November 3, 1982
MN-82-222

Subject: YAEC-1296P DNBR Limit Methodology for Maine Yankee

Responses to NRC Questions on YAEC-1

FIGURE 2.1

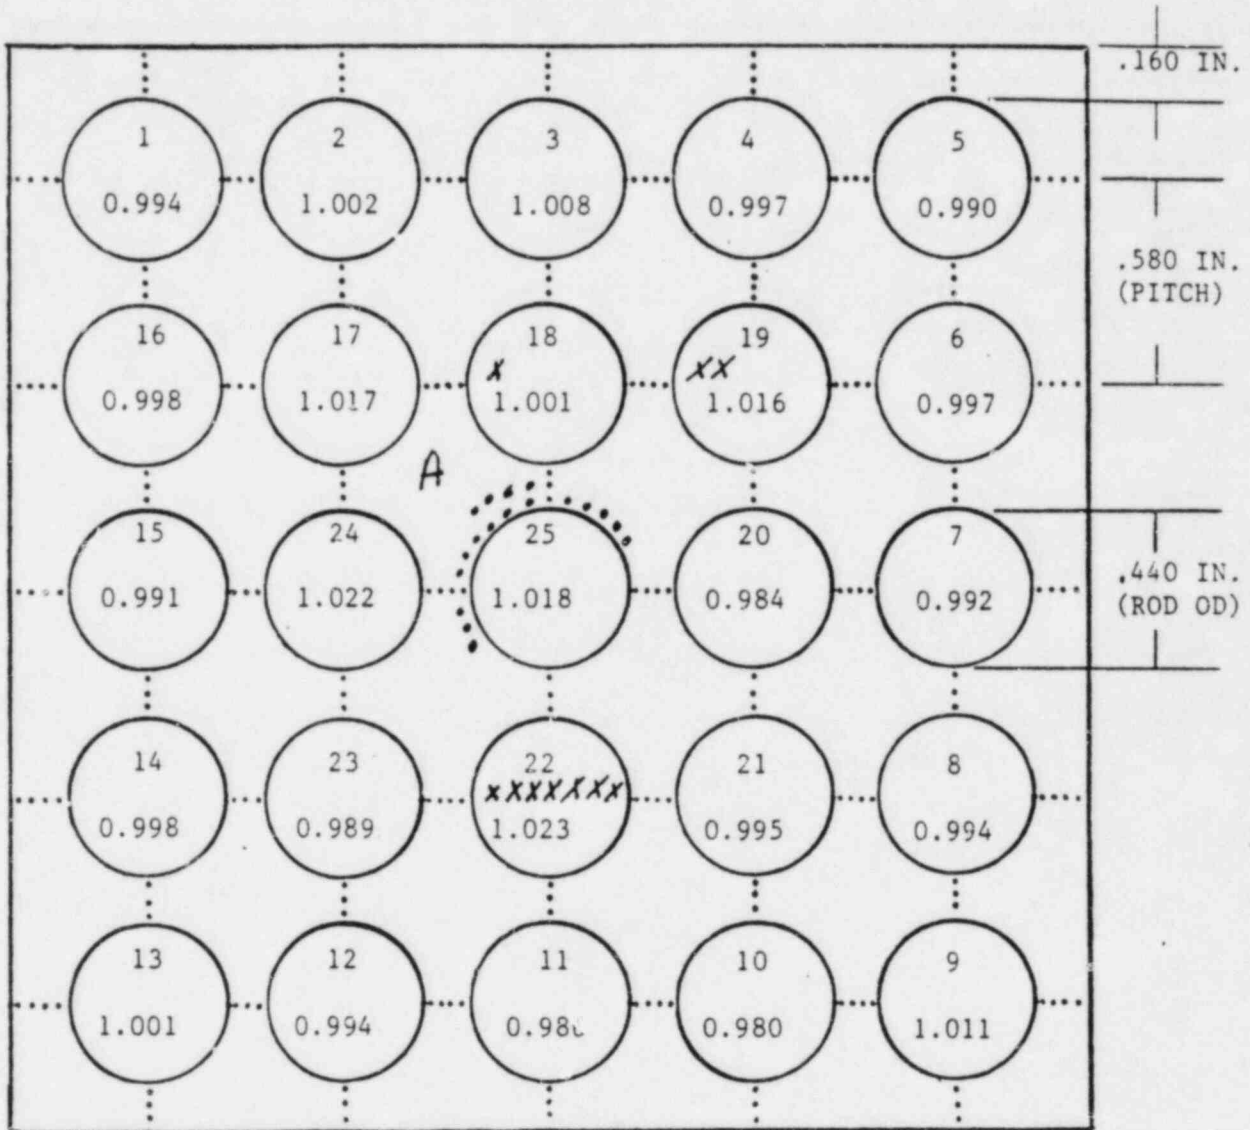
Provide measured and predicted DNB locations, both axially and radially, for each data point.

Figures 2.1, 2.3 and 2.5, as designated in YAEC-1296P, graphically present the radial location accuracy. Figure 2.1 shows the experimental radial location of the first indication of DNB. We limited our analysis to the first indication of DNB since this is the parameter most equivalent to minimum DNB, as required in the safety analysis. The prediction from the COBRA model for Test Section 21 is a constant Rod 24, Channel A (designated in Figure 2.1). As shown, the predominate DNB channel is accurately predicted. The rod COBRA calculates, however, is incorrect. Due to the closeness of the power peaking in the rods of interest, the fact that the first indication is incorrect is not considered a significant discrepancy.
